Berowra Waters Eastside Marina
Kirkpatrick Way, Berowra Waters

Modification DA 150-06-01 MOD 4

Modification of Minister's Approval
Section 96(2) of the
Environmental Planning and Assessment Act 1979

Figure 5: Comparison between location of existing pontoons (shown in blue) and proposed pontoons (shown in green) (Source: Provided by the Applicant, 19 May 2010)

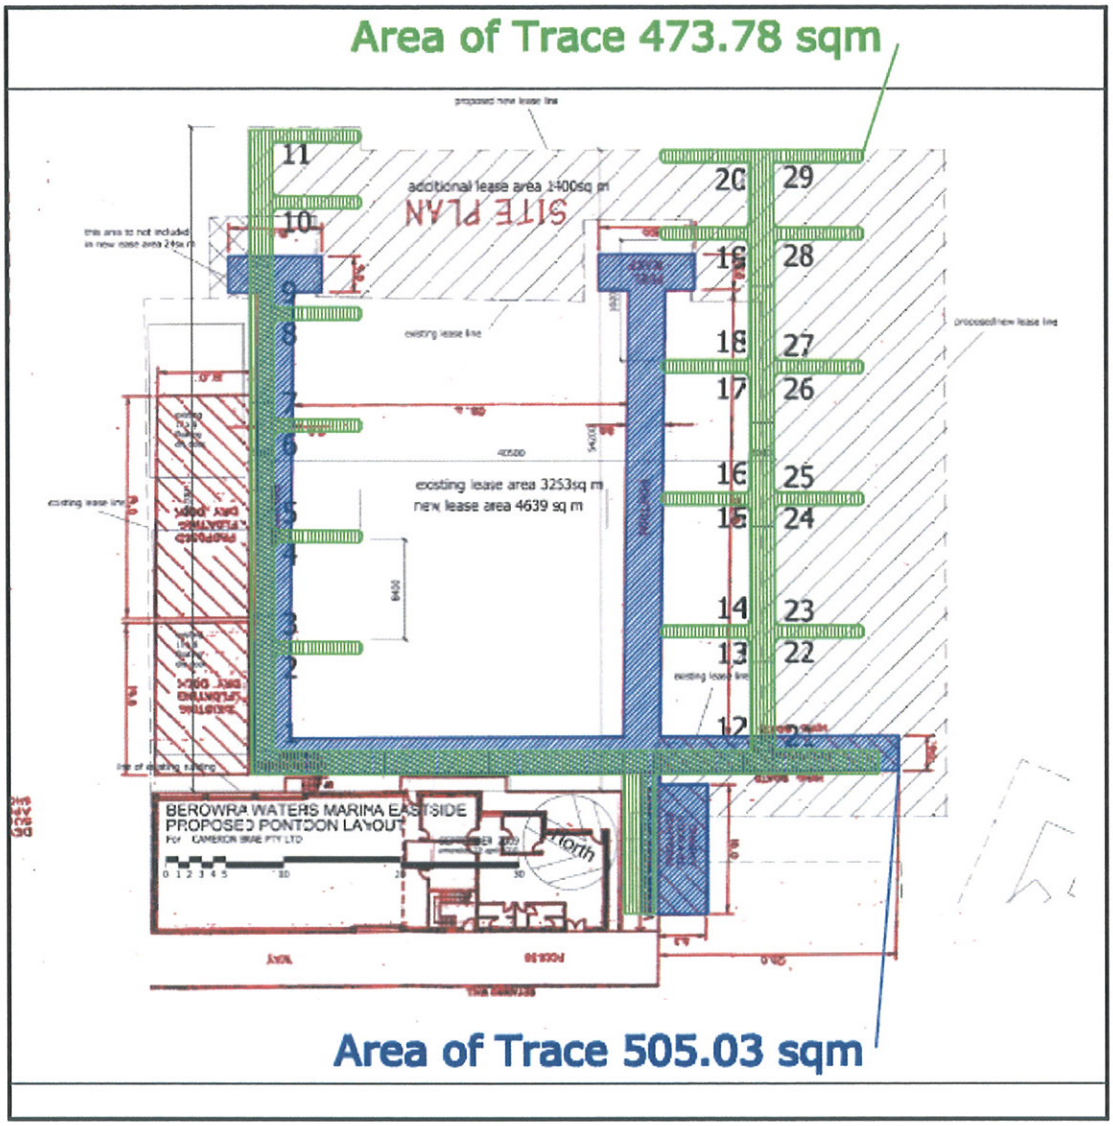
The modified site plan showing the proposed modifications is included in **Appendix C**, and a site plan comparison between the originally approved configuration and the proposed modified configuration is shown in **Figure 5** below.

The modifications will require a larger lease area with the extension of the northern and southern pontoons, and the relocation of the northern pontoon northwards. The required lease area increases by 1376sqm from 3,263sqm to 4,639 sqm. However, the Applicant has stated that the footprint of the proposed new pontoons will be slightly smaller due to the narrower pontoons (refer **Figure 5** above and **Appendix C)**.

Department's Comment:
The modifications are not classified as further development of the site. It is recognised that the lease area of the Marina will be larger as a result of the modifications however the overall footprint of the Marina will be smaller (refer **Figure 5** above).

REQUESTED MODIFICATION	DEPARTMENT'S RESPONSE	SUPPORTED
Structural Amendments		
Relocation of the northern pontoon arm northwards (approximately 8 metres)	The new configuration of the pontoons, with a greater separation between the north and south pontoon arms, will comply with *AS 3692-1991 Guidelines for Design of Marinas.* The relocation of the pontoon arm will not cause any navigation issues.	**YES**

Figure 6: Revised Site Survey plan (22/4/10) of the Eastside Marina

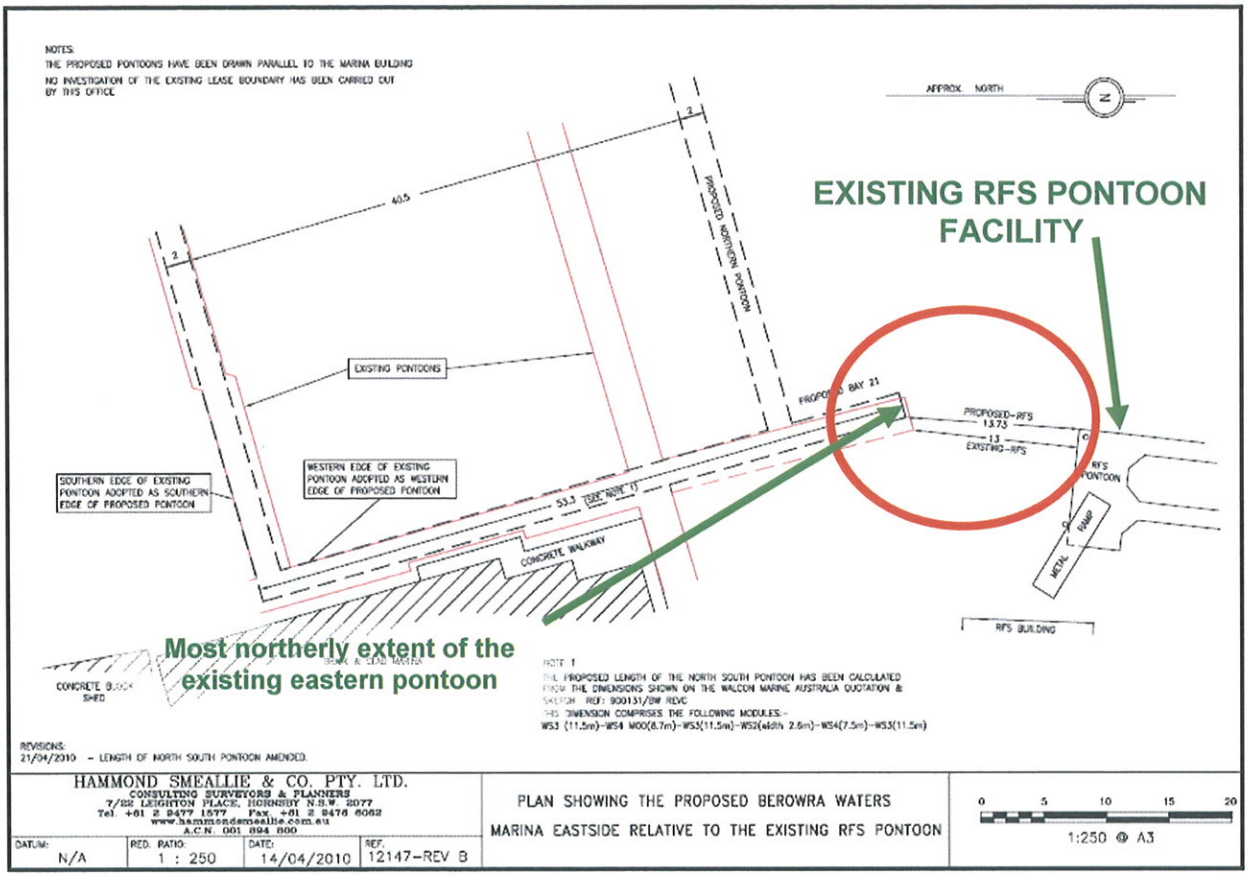
The RFS have no objection to the application, however were concerned that the extension of the north-south pontoon would create navigation issues and the distance between the facilities for safe manoeuvrability be carefully considered.

On 22 April 2010, the Applicant submitted a revised site survey plan (refer **Figure 6** above) that reduces the length of the north-south eastern foreshore pontoon to less than the length of the existing pontoon, thus increasing the separation with the RFS pontoon. A corresponding amended modification plan, dated 22/4/10 was also submitted (refer **Appendix C**).

The distance between the Eastside Marina pontoon and the neighbouring RFS pontoon is therefore increased. As a result the proposal will not create additional navigation issues, but rather improve the current situation
